**MODIFICATION REQUEST:
Graythwaite Rehabilitation Centre
Ryde Hospital
Fourth Avenue, Denistone
(MP10_0179 MOD 1)**

Director-General's
Environmental Assessment Report
Section 75W of the
Environmental Planning and Assessment Act 1979

August 2012

Figure 5: Proposed Modified Western Elevation (original roof plant shown by dashed red line)

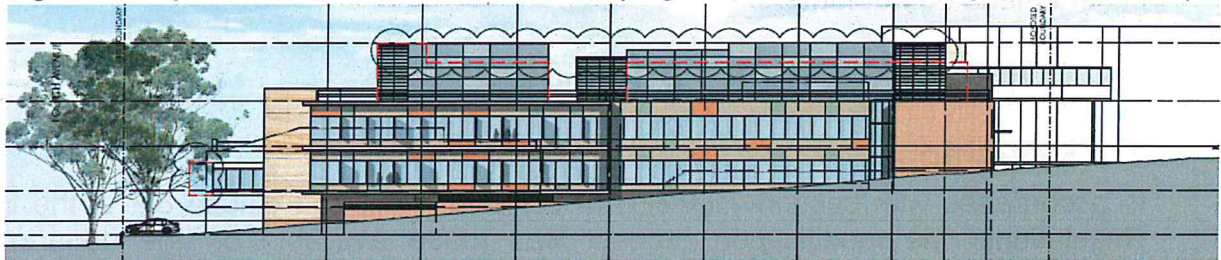
- increasing the height of roof plant rooms from RL 105.0 to RL 106.7 (increase of 1.7 m)
- reconfiguration of the southern roof plant room
- reconfiguration of the building entry area on the ground floor and a revised awning design
- reconfiguring the reception desk area, and introducing a waiting area on level 1
- increasing the GFA from 4,309.45 sqm to 4,324.25 sqm (increase of 14.8 sqm) as a result of the introduction of a waiting area
- reducing the entry driveway width off Fourth Avenue
- introduction of a separate ambulance parking bay

The proposed increase in the height of roof plant is illustrated in Figure 5.

The proposed modification seeks approval to raise the height of the two roof plant rooms by 1.7 m to a height of RL 106.7, resulting in the plant rooms being the same height as the stair shaft and lift overrun (being the maximum height of the approved project). The height of the plant rooms themselves would increase from 3.5 m to 5.2 m. The proposed modification also seeks to alter the layout of the southern plant room, including a revised setback from the southern edge of the building, and the addition of a cooling tower towards the north plant room. The proponent has identified that the height increases and layout alterations are required to accommodate the required clearances of the plant equipment to be contained within. A comparison of the approved and proposed modified roof plans (showing the proposed height changes to the roof plant rooms) are provided in Figures 6 and 7.

- there are no height controls applicable to the site
- the proposed height increase will not exceed the maximum RL of the approved project

- the additional plant height and reconfiguration will not result in any substantial change to the appearance of the building
- the hospital campus contains a number of other buildings up to four storeys in scale with higher RL's than the approved project
- the plant rooms will remain setback from the outer edges of the building and will therefore continue to be only partially visible from ground level
- the plant rooms (as modified) are significantly removed from surrounding residential development, and therefore will not result in any substantial visual impacts on surrounding residential areas.

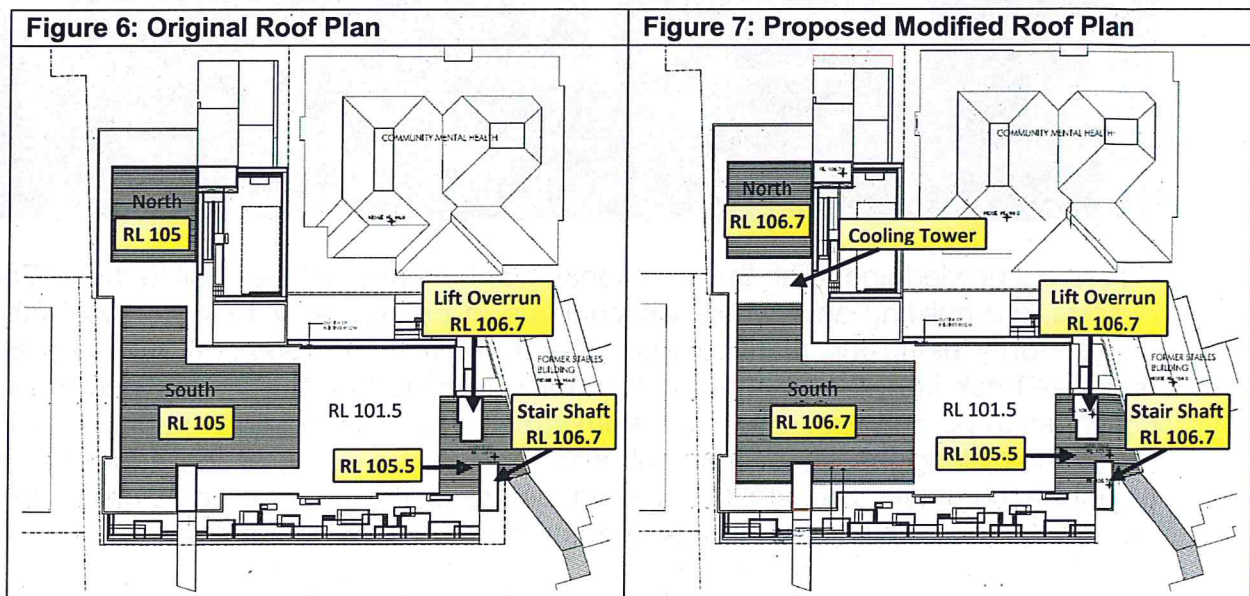
Whilst the maximum RL height of the approved project is not proposed to increase, the raised height of the north and south plant rooms will result in some additional building height (being the vertical distance between ground level (existing) and the

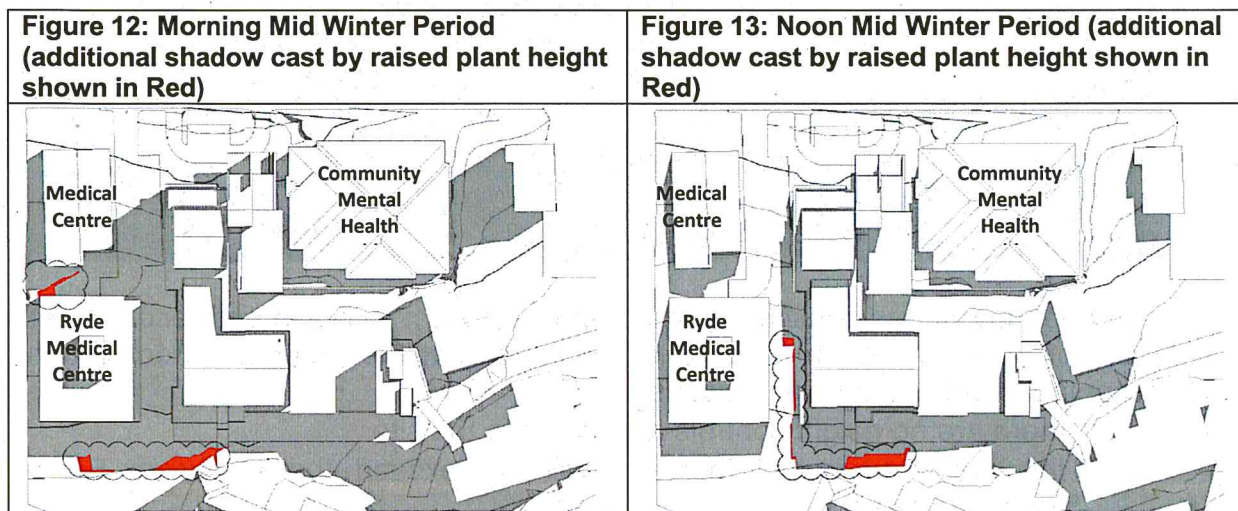
The proposal includes a revised awning design fronting Fourth Avenue (see Figure 9), minor reconfiguration of the building entry on the ground floor, and minor reconfiguration of the reception desk area and introduction of a waiting area on level 1.

The revised awning design is required to allow clearance for a drainage easement at the front of the building, meaning the awning is now two meters shorter than the awning in the approved project. The reconfiguration of building entry is proposed to accommodate the inclusion of an ambulance parking bay. Reconfiguration of the reception desk area and introduction of a waiting area is required to accommodate a larger area for patient transfers and admissions. The waiting area is located where there was previously void space in the approved project, and consequently the GFA of the building is proposed to increase from 4,309.45 sqm to 4,324.25 sqm (increase of 14.8 sqm).

The department considers that the minor increase in GFA as a result of the waiting area is acceptable given it will not result in any substantial change to the bulk of the approved building. The department acknowledges that the revised awning design is required to accommodate a drainage easement, and considers that the minor internal reconfigurations are acceptable given they will improve the overall functionality of the building.
